ITEM: ZON-000577-2025 – ConocoPhillips General Development Plan, 2nd Amendment

REQUEST: Approval of Resolution No. 20, Series 2025, recommending to the City Council approval with conditions of the ConocoPhillips Campus General Development Plan, 2nd Amendment

CONOCOPHILLIPS CAMPUS

GENERAL DEVELOPMENT PLAN AMENDMENT 1

GENERAL DEVELOPMENT PLAN

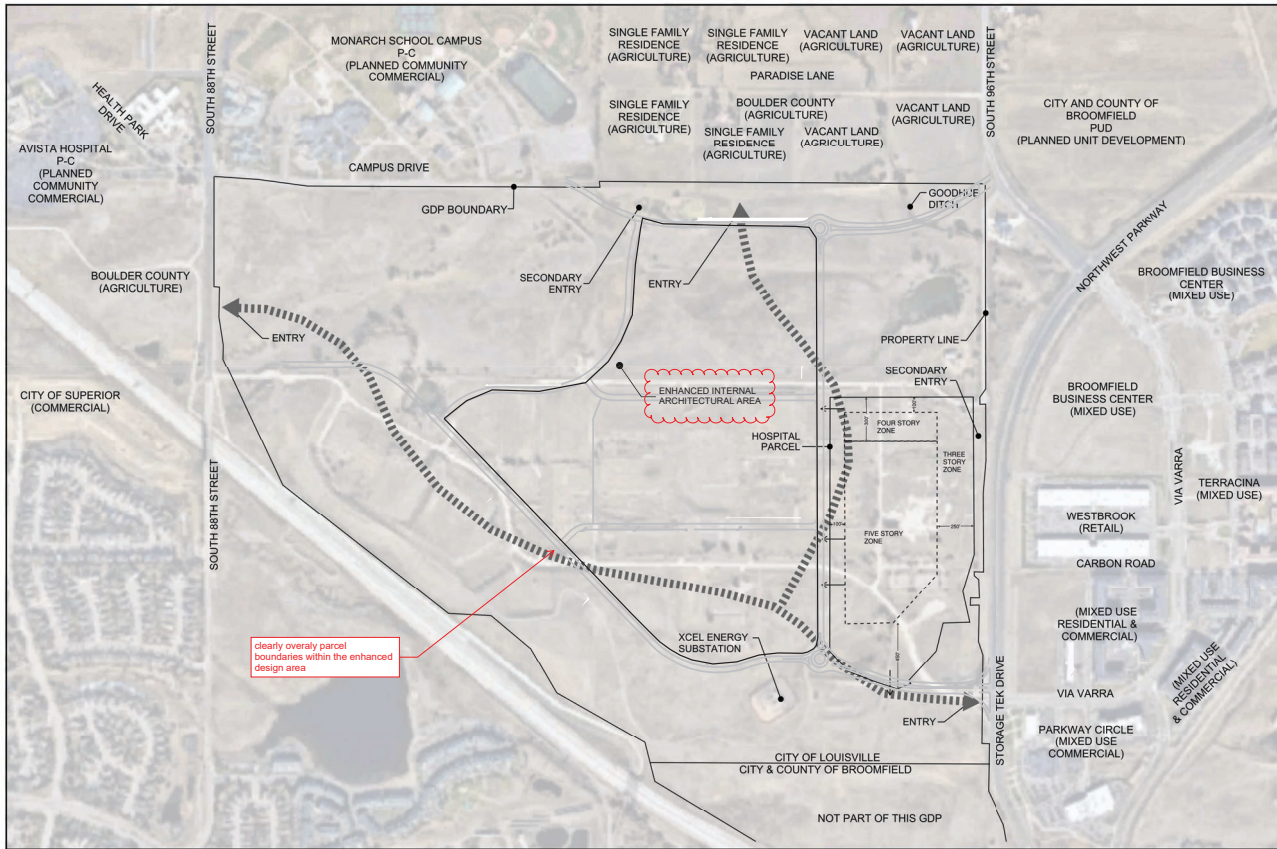
Add this note

Lots 1, 2, 3, and 5 of Block 1 of Redtail Ridge Filing No. 1 shall conform and be consistent with the Louisville Municipal Code, the Industrial Development Design Standards and Guidelines, and the enhanced design standards contained herein

Add this note 1

Unless otherwise noted,

clearly overlay parcel boundaries within the enhanced design area

ENHANCED DESIGN STANDARDS APPLICABLE TO INTERNAL PARCELS INCLUDING LOT 1, BLOCK 1, LOT 2, BLOCK 1, LOT 3, BLOCK 1, LOT 5, BLOCK 1:
